SUBJECT: Forwards technical & schedular info re SEP Topic III-56A re effects of pipe break on structures, sys & components, inside containment, per NRC 810630 request.

Subject: SEP Topic III-5.A, Effects of Pipe Break on Structures,
Systems and Components Inside Containment
R. E. Ginna Nuclear Power Plant
Docket No. 50-244

SEP TOPIC III-5.A
HIGH ENERGY LINE BREAKS INSIDE CONTAINMENT

R. E. GINNA NUCLEAR POWER PLANT
DOCKET NO. 50-244

FIGURE - 1

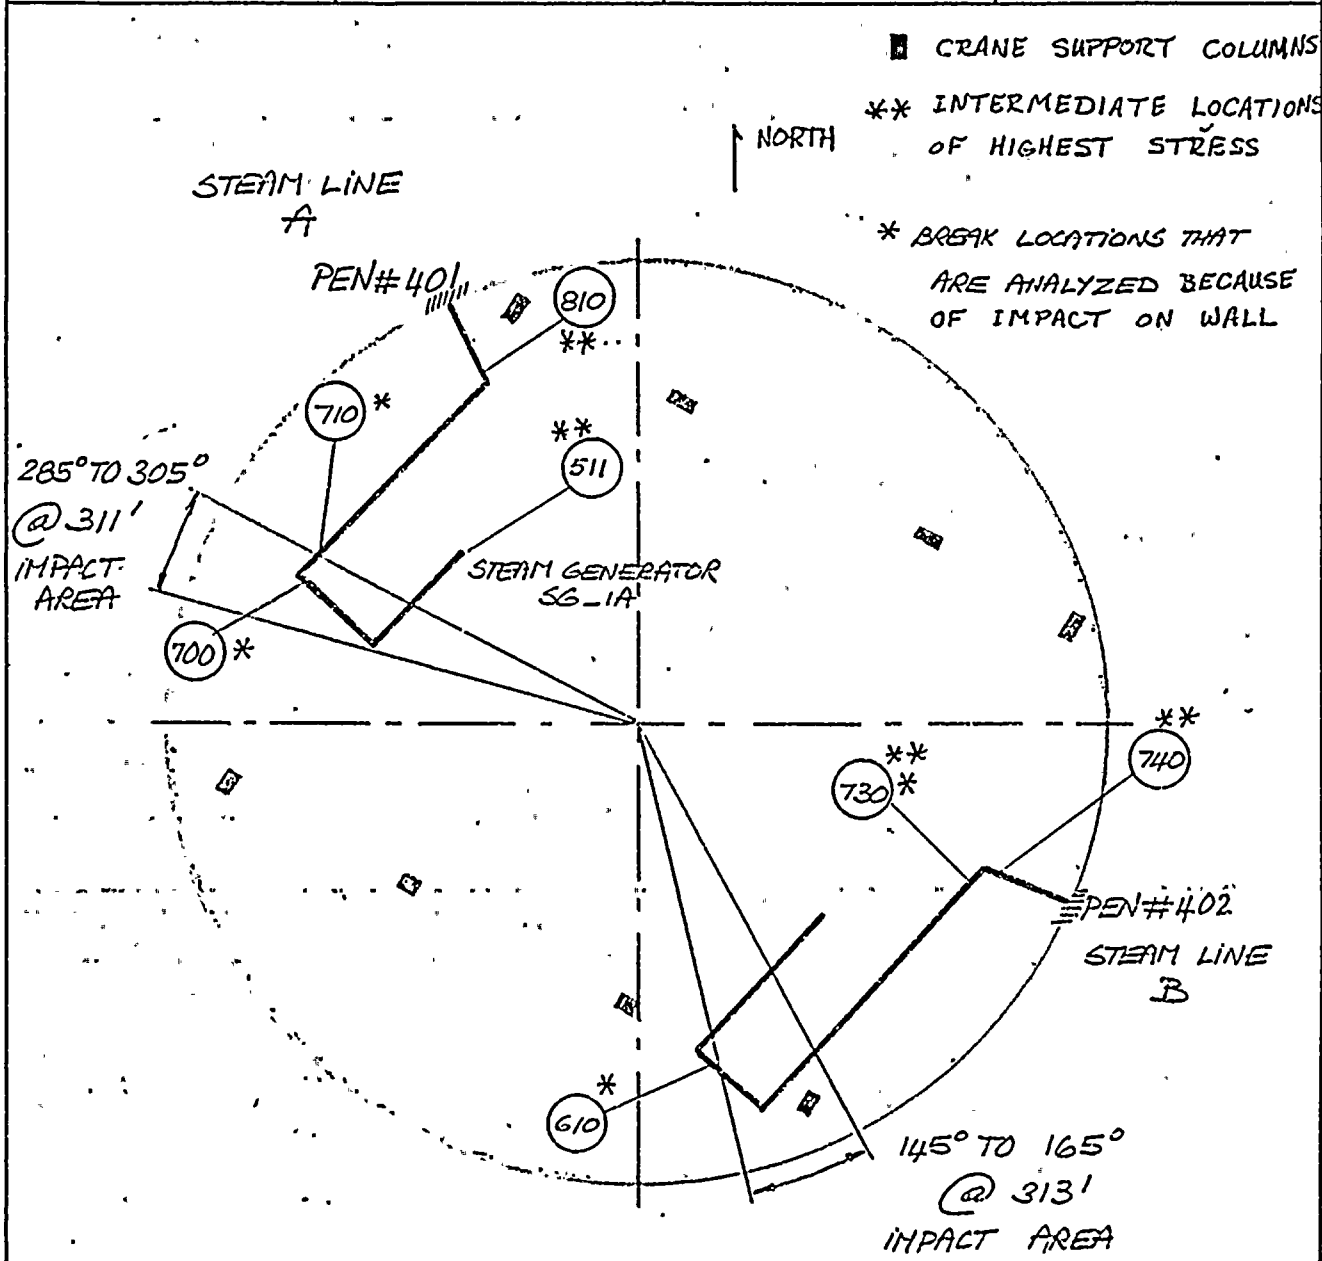
2. A break in either a main steam or main feedwater line could impact the containment wall. The licensee must demonstrate that the pipe whip will not result in penetration of the containment wall. If some loss of containment function occurs an assessment must be provided of the consequences.

Because an effects-oriented evaluation of the main steam and feedwater lines could not rule out the potential for a ruptured line striking the containment wall, a mechanistic evaluation of the main steam line was performed. The analysis methods used made evaluation of the main steam line a conservative envelope for both main steam and feedwater line rupture effects upon the containment wall. The thrust force applied by the escaping fluid to the pipe was calculated by multiplying the initial pressure by the pipe cross-sectional area. The steam line force calculation thus envelopes the feedwater force calculation. The evaluation of pipe whip effect on containment wall integrity was performed for both main steam lines A and B. The piping stress analysis results from the RGE seismic upgrade program were used in the evaluation. The piping break locations were postulated at the following locations:

Table 1 provides the location of the maximum stress combinations $S_{O1} + S_E$ for each main steam line; these locations are shown in Figure 1.

Since none of the combinations $S_{o1} + S_E$ exceeds the stress limit, circumferential breaks are assumed at the two intermediate points of maximum stress.

These variables have been evaluated for the break cases considered in Figure 1. In this evaluation, the effect of the existing pipe supports and the crane structure were neglected to maximize the impact upon the wall. This is conservative since these restraints tend to decelerate the pipe motion and, therefore, decrease the striking velocity v_o .

The results of the analysis are provided in Table 2 and the impact zones of the containment wall are shown in Figure 1.

It should be noted that the two intermediate locations of highest stress do not result in an impact on the containment wall and therefore no further analyses are required. Nonetheless, to provide additional confidence that postulated breaks will not yield a ruptured containment wall, the highest stressed location in each steam line which results in an impact upon the wall has been evaluated. The locations considered are #700 on MSL A and #610 on MSL B (see Figure 1).

For break location #700: MSL "A" X = 13.96"
 For break location #610: MSL "B" X = 3.48"

The analysis for missile penetration into the wall considering overall wall response resulted in $X_m/X_c = 1.352$. This is considerably less than the allowable ductility ratio for impulse loads for flexure in structures. The rectangular impulse load considered:

The conclusion of these analyses is that, even neglecting the three-eighths inch steel liner plate, structural integrity of the containment shell is assured.

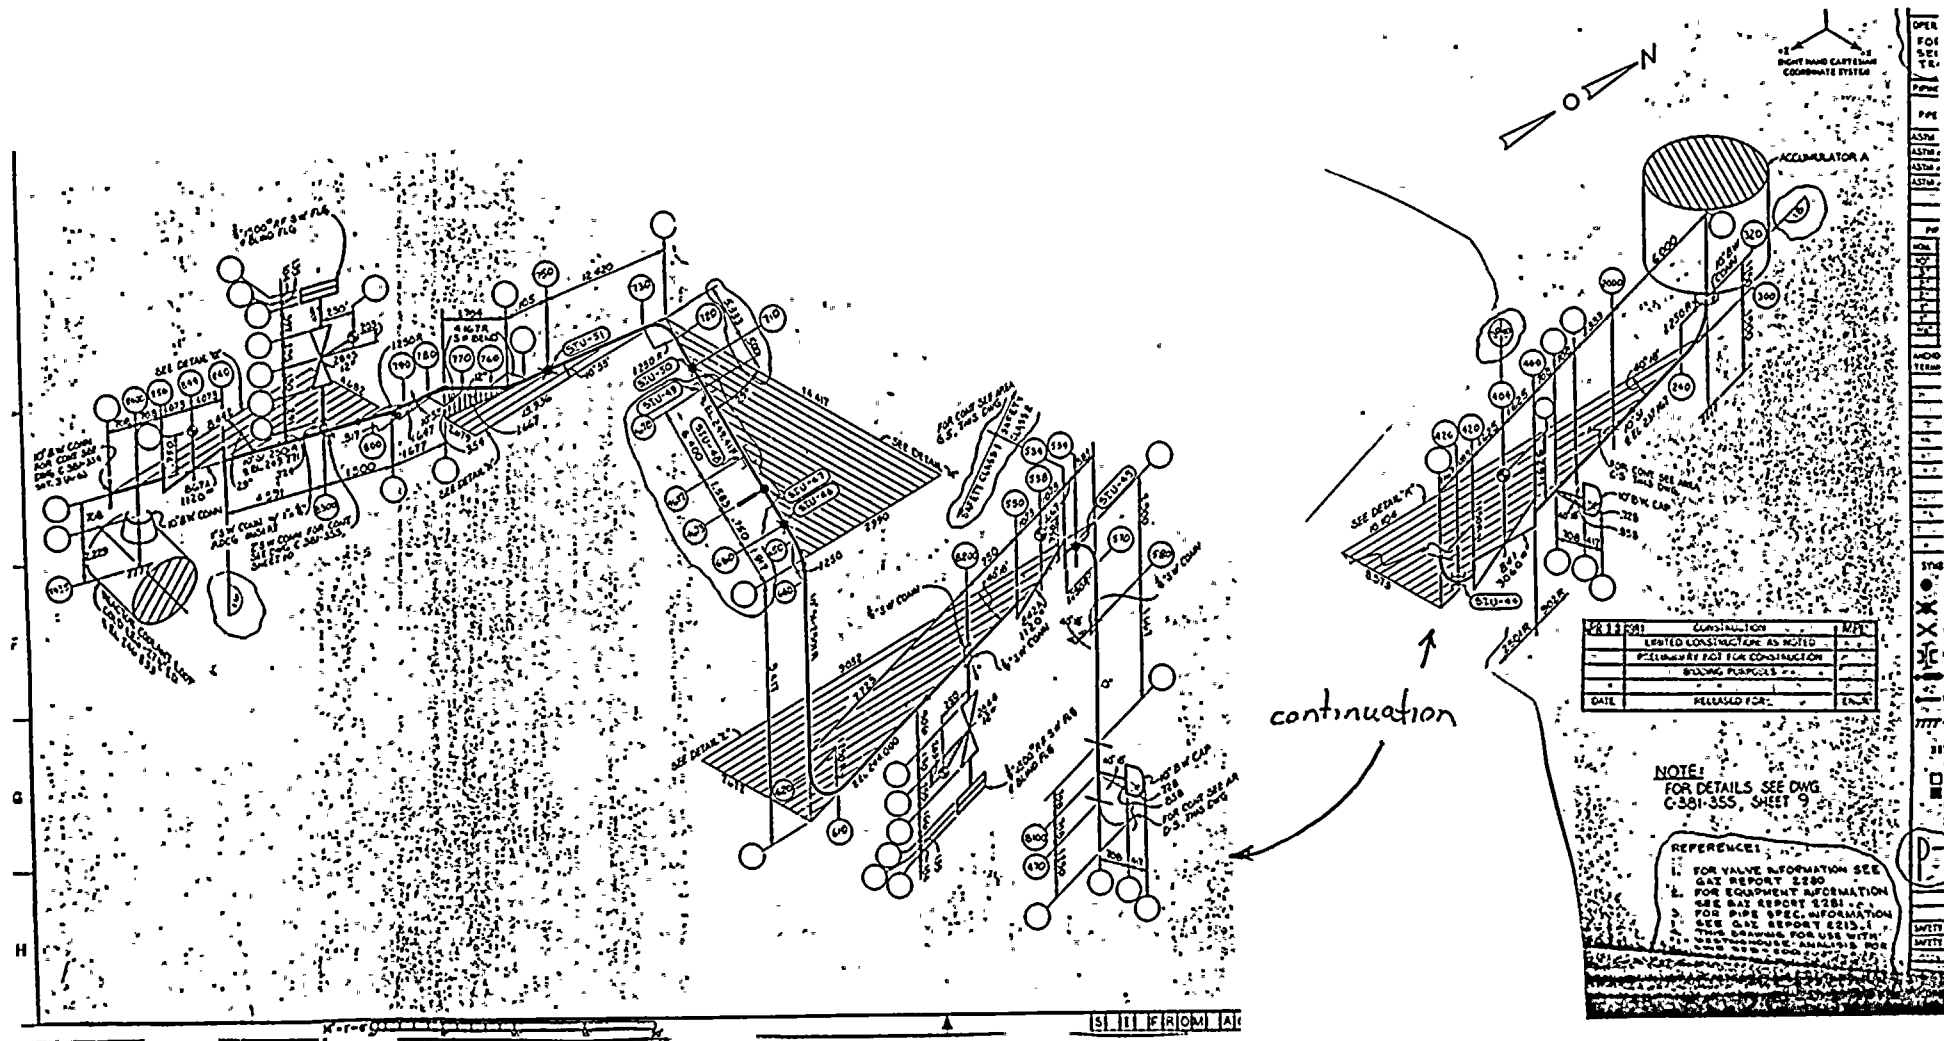
4. A break in the accumulator line between the tank skirt and the loop compartment walls could interact with the LPSI lines (resulting in a LOCA) and with the RHR outlet line. A break could also impact containment spray or safety injection lines. Breaks in this line could also interact with cables for instrumentation circuits, the LPSI valve controls and fan coolers. The licensee must demonstrate that the consequences of this scenario are acceptable, provide restraints and protection or demonstrate that breaks need not be postulated in this area based on a mechanistic evaluation.

Breaks in the A accumulator line between the accumulator tank skirt and the loop compartment walls will not, by themselves, result in a loss of primary coolant. Check valve 867 located inside the B loop compartment will prevent loss of primary coolant. Only accumulator fluid will be lost as a result of the break. Interaction with other equipment is acceptable provided the interaction does not cause loss of primary inventory or interfere with maintaining the plant in a safe shutdown condition. Therefore, equipment required only for mitigation of LOCA's or large secondary system breaks need not remain functional for the accumulator break and items c, d, f, and g may be eliminated from consideration. The remaining items, a, b and e require evaluation.

The A accumulator line stresses have been determined in the seismic upgrade program. Stresses in the line are low and generally are only 10 to 25 percent of allowable. Two intermediate break locations have been examined based upon the highest stress locations. One of these locations is inside the loop B compartment where no interactions with surrounding equipment will result in adverse effects.

The second intermediate location is at node 420 near valve MOV 841 and is shown in Figure 2. The stress at this location is less than 4000 psi. The allowable stress is greater than 27,000 psi. The stress at node 420 is so low that a break at this location should not be postulated.

If a break is postulated at node 420, piping downstream of the node will not whip because the line is filled with cold water with no sustained high energy source available. Check valve 867A prevents blowdown of the RCS. The line between the elbow at node 420 and the tank skirt is a straight run of piping near the floor and separated from the LPSI line by at least 15 feet, a distance greater than the length of pipe between the tank skirt and node 420. Portions of the RHR line are closer to the accumulator line but are also out of reach of the pipe segment between the tank skirt and node 420. Valve 700, located in the A loop compartment, provides isolation from the primary system. If a rupture is postulated at node 420, the pipe may deflect downward or even strike the floor but the pipe deflection will not be toward the RHR line or the LPSI line (see drawing E-303-603 in reference 1).

Therefore, rupture of the 10 inch accumulator line should not be postulated because of the applicability of "leak before break" established by TAP A-2 work and because stresses in the line are very low. Further, even if rupture of the line at the two highest stressed intermediate locations is postulated, the break will not adversely affect required equipment.
